OFFICE OF RIVER PROTECTION

SUBMITTAL OF HANFORD FACILITY RESOURCE CONSERVATION AND RECOVERY ACT PERMIT MODIFICATION NOTIFICATION FORM 24590-LAW-PCN-ENV-17-012

**Hanford Facility RCRA Permit Modification Notification
Form 24590-LAW-PCN-ENV-17-012**

Hanford Facility RCRA Permit Modification Notification Form
Part III, Operating Unit 10
Waste Treatment and Immobilization Plant

SCALE: NONE
 24590-LAW-M6-LOP-00002002 REV 1

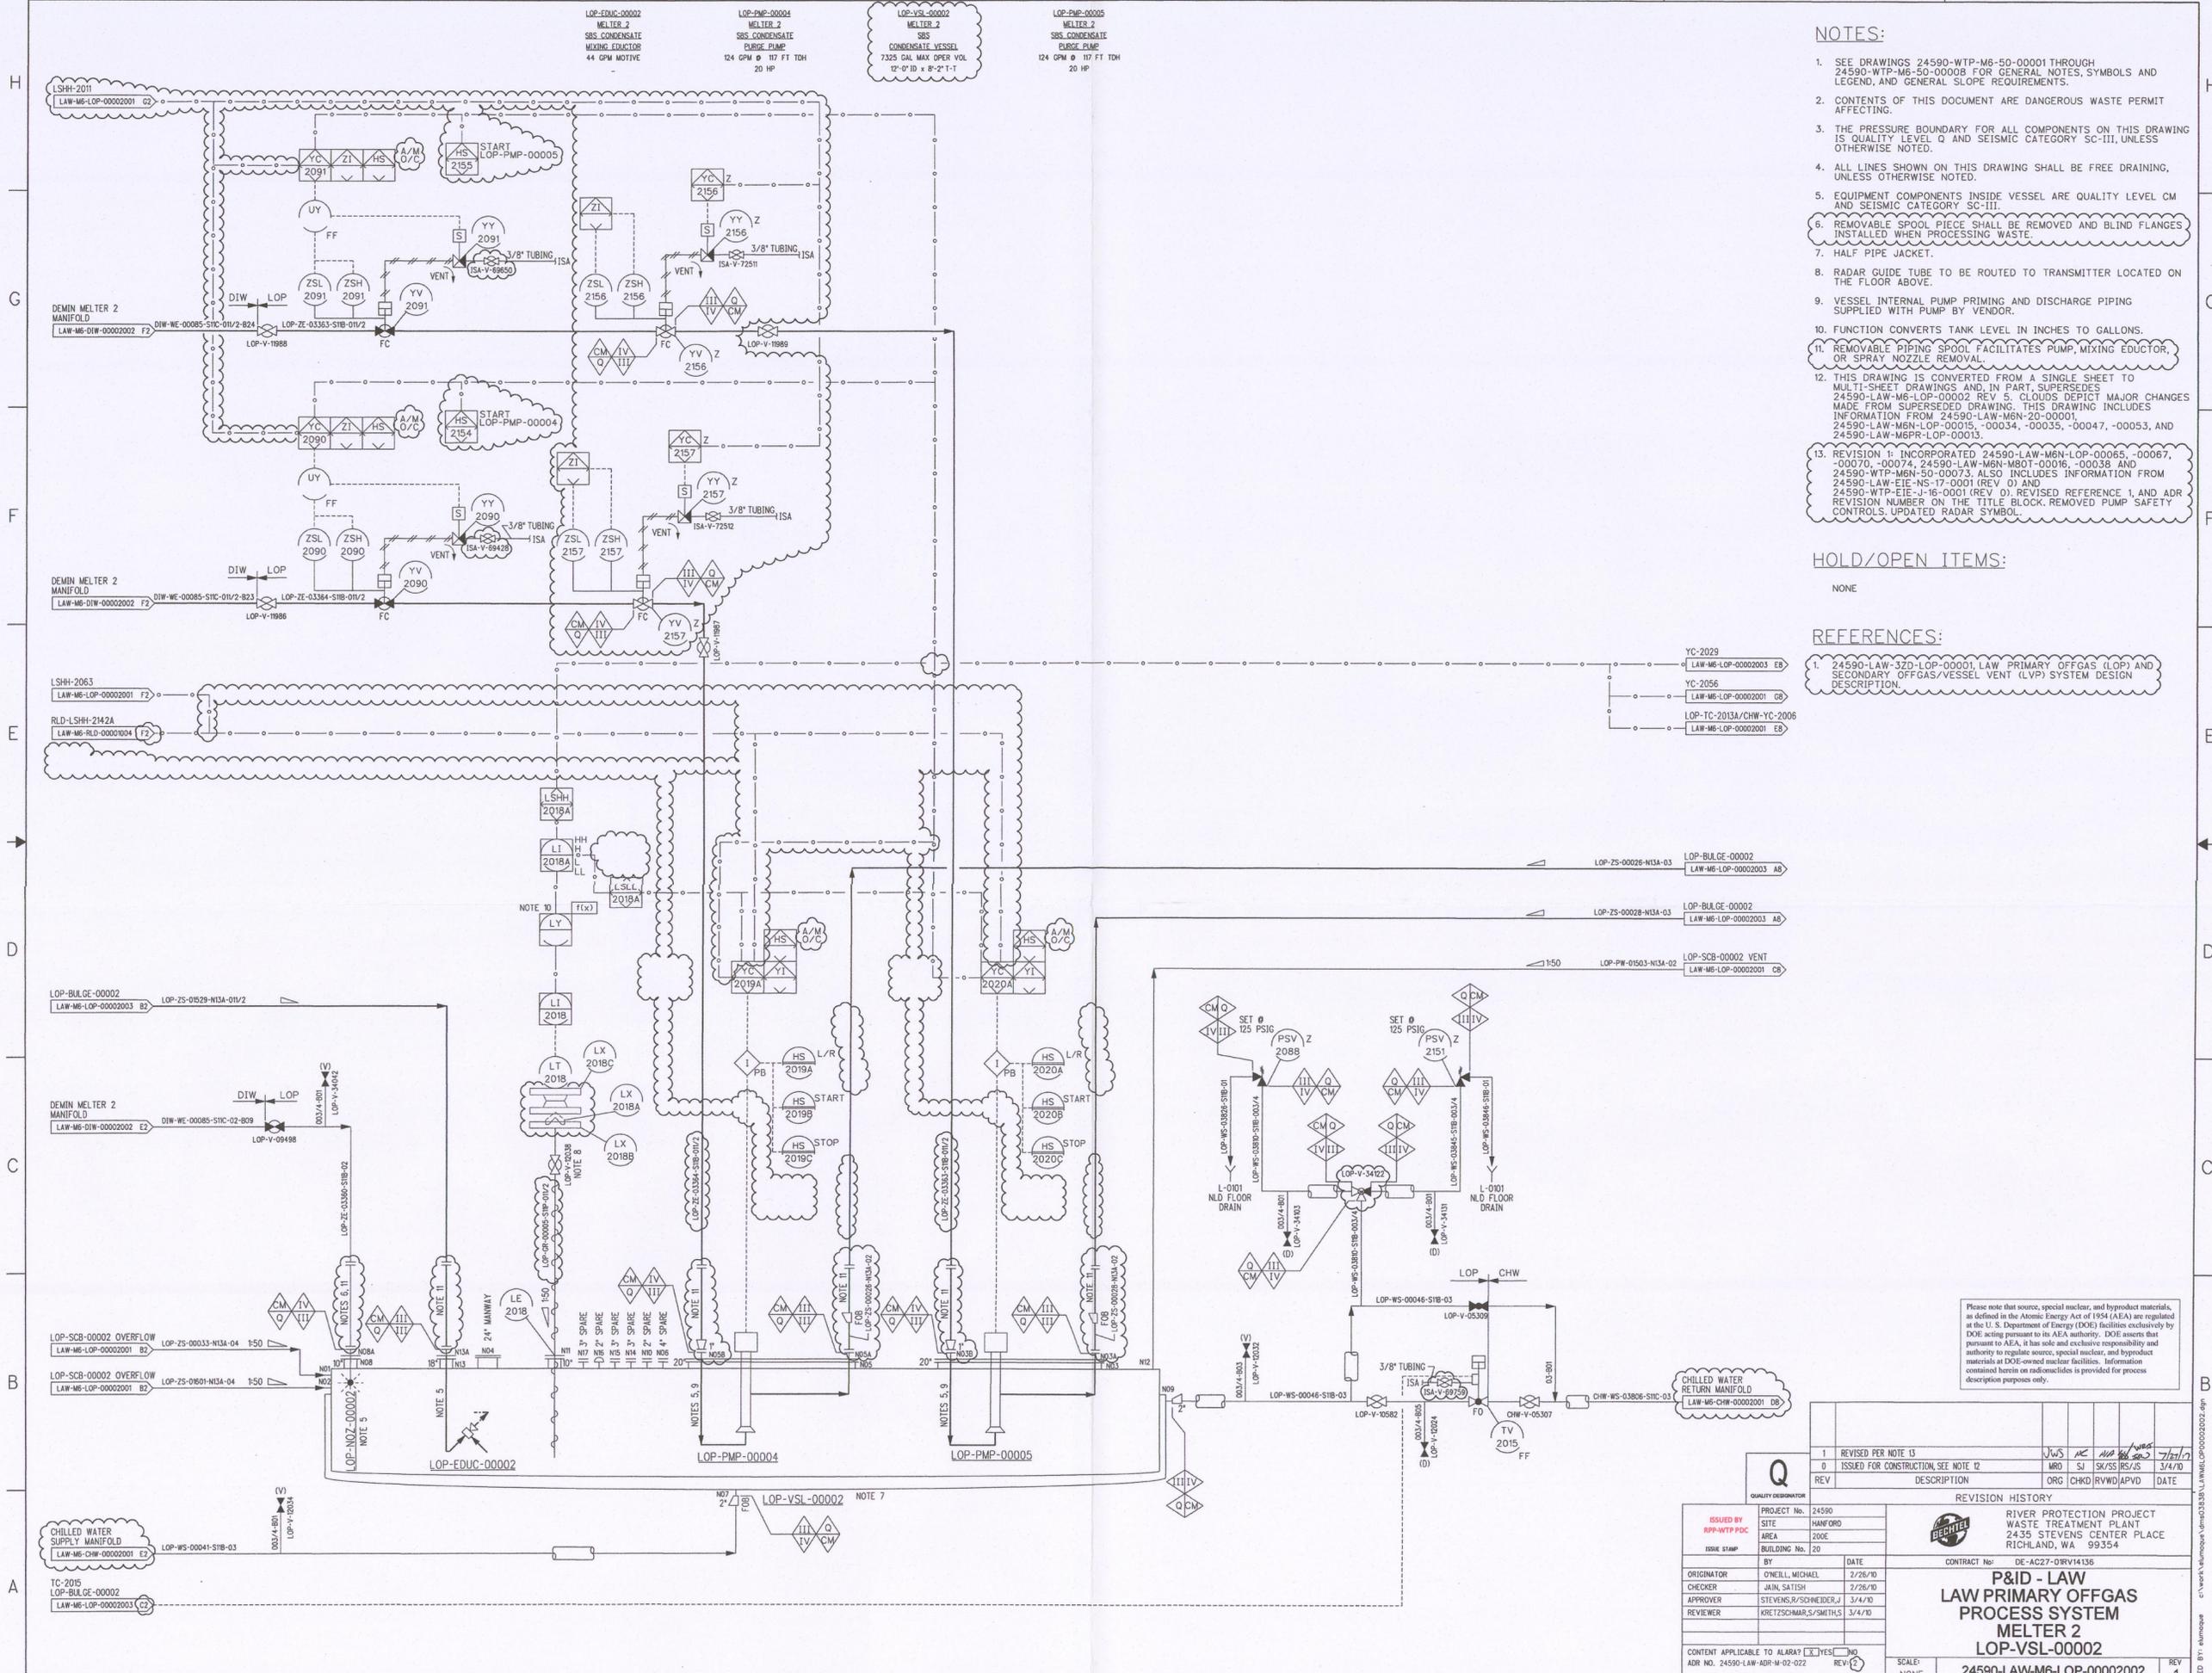
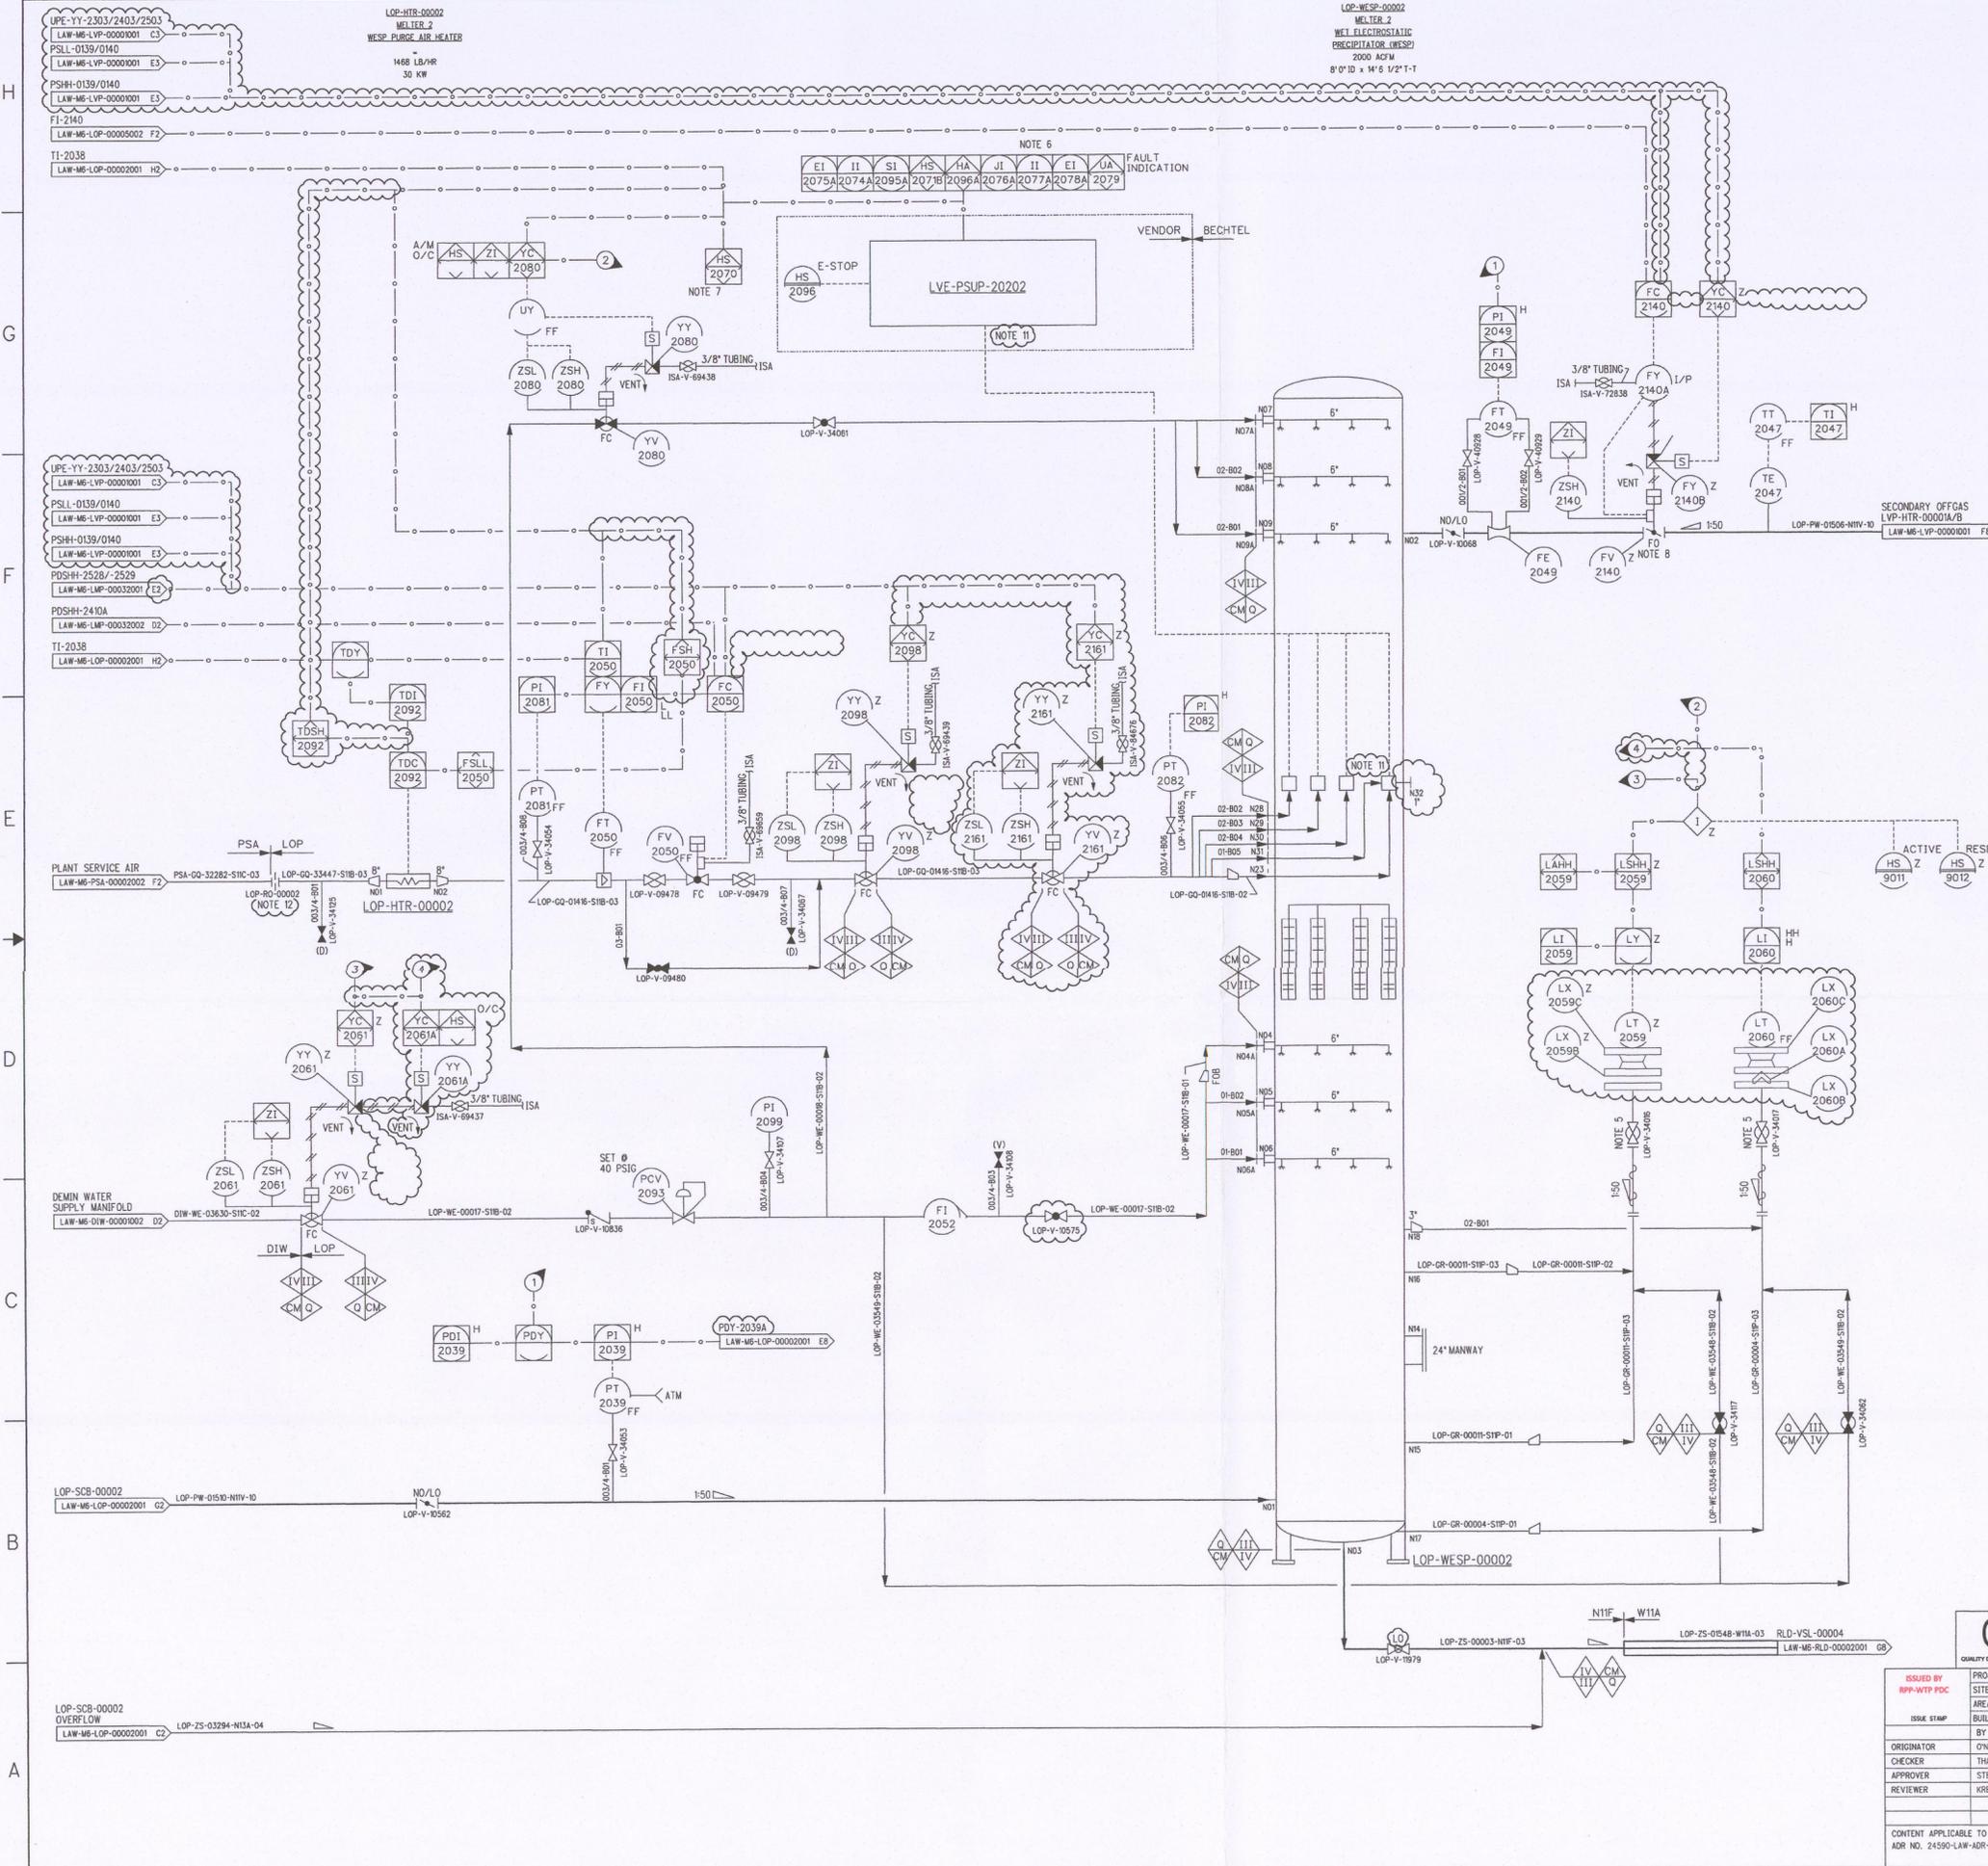
Changes to the P&ID (24590-LAW-M6-LOP-00002002, Rev. 1) for the Melter 2 Submerged Bed Scrubber (SBS) Condensate Vessel (LOP-VSL-00002) are summarized below:

- Added or modified notes in the Notes section. Revised the References section.
- Added LOP-HS-2154 and LOP-HS-2155 to automatically start pumps LOP-PMP-00004 and LOP-PMP-00005 and automatically open valves LOP-YV-2090 and LOP-YV-2091 (Grids F7 and H7).

- Added the label "A/M" (auto/manual selector switch on operator display faceplate) for hand (manual) switches (Grids D5, D6, F7 and H7).
- Deleted instrumentation LOP-LSL-2018A (Grid E6).

- Moved off-sheet connector for level switch (high-high) LSHH-2011 and changed instrumentation control strategy by the addition, modification or deletion of instrumentation, lines, and valves (multiple grids).

- Revised graphical representation/depiction for remote radar level instrumentation LT-2018 (Grid C7).
- Changed valve symbol from gate valve to ball valve for ISA-V-69428, ISA-V-69650, ISA-V-69759, ISA-V-72511 and ISA-V-72512 (Grids B3, D3, F6 to F7 and G6 to G7).

- Added seismic and quality flags for valves YV-2156 and YV-2157 (Grids F6 and G6).
- Updated the maximum operating volume for vessel LOP-VSL-00002 (Grid H5).

- Moved blind flanges closer to the nozzles (Grids B4 to B7).
- Added or moved piping labels closer to the nozzles (Grids B4 to B5 and C5 to C6).
- Changed valve symbol from 3-way ball valve to 3-way plug ball valve for ISA-V-34122 (Grid C3).

- Revised the diameter size from ½" to 1½" for piping LOP-GR-00005-S11P-011/2 (Grid C6).
- Revised or moved off-sheet connectors (multiple grids).
- Incorporated changes from change documentation identified in the Notes section.
